TRANS/WP.29/GRE/2004/28/Rev.1 20 January 2005

PROPOSAL FOR DRAFT AMENDMENTS TO REGULATION No. 48 (Installation of lighting and light-signalling devices)

Transmitted by the Informal Group "Adaptive Front-lighting Systems (AFS)"

Apparent surfaces of lighting units 1 through 11 of an AFS (example)

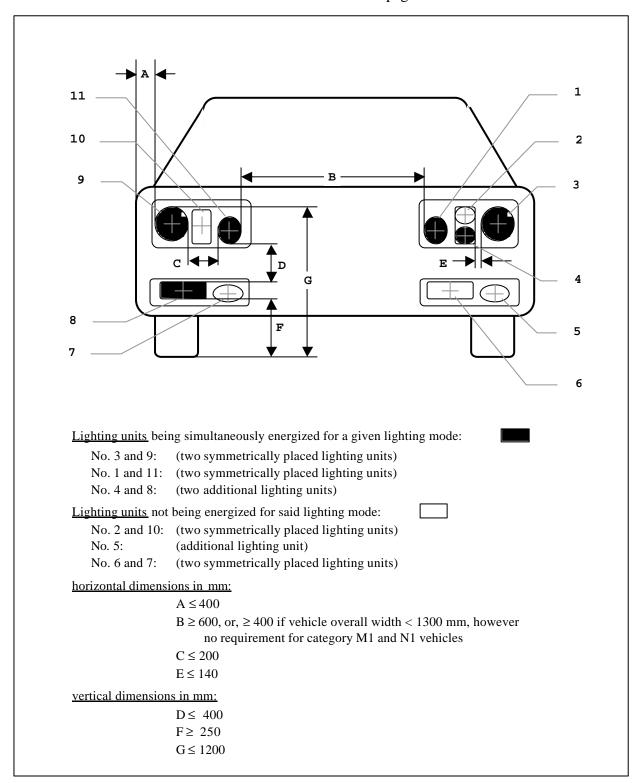
- 6.22.4.1.2. Additional lighting units, if any, on either side of the vehicle shall be positioned at a distance not exceeding 140 mm 7/ in horizontal direction (E in the figure) and 400 mm in vertical direction above or below (D in the figure) from the nearest lighting unit;

- 6.22.4.1.3. None of the additional lighting units described in paragraph 6.22.4.1.2. above shall be positioned lower than 250 mm (F in the figure) nor higher than indicated in paragraph 6.2.4.2. of this Regulation (G in the figure) above the ground;

the outer edge of the apparent surface of at least one lighting unit on each side of the vehicle shall not be more than 400 mm from the extreme outer edge of the vehicle (A in the figure); and,

the inner edges of the apparent surfaces in the direction of the reference axes shall be not less than 600 mm apart. This does not apply, however, for M_1 and N_1 category vehicles; for all other categories of motor vehicles this distance may be reduced to 400 mm where the overall width of the vehicle is less than 1300 mm.

^{7/} In case of additional "two symmetrically placed lighting units" the horizontal distance may be 200 mm (C in the figure).
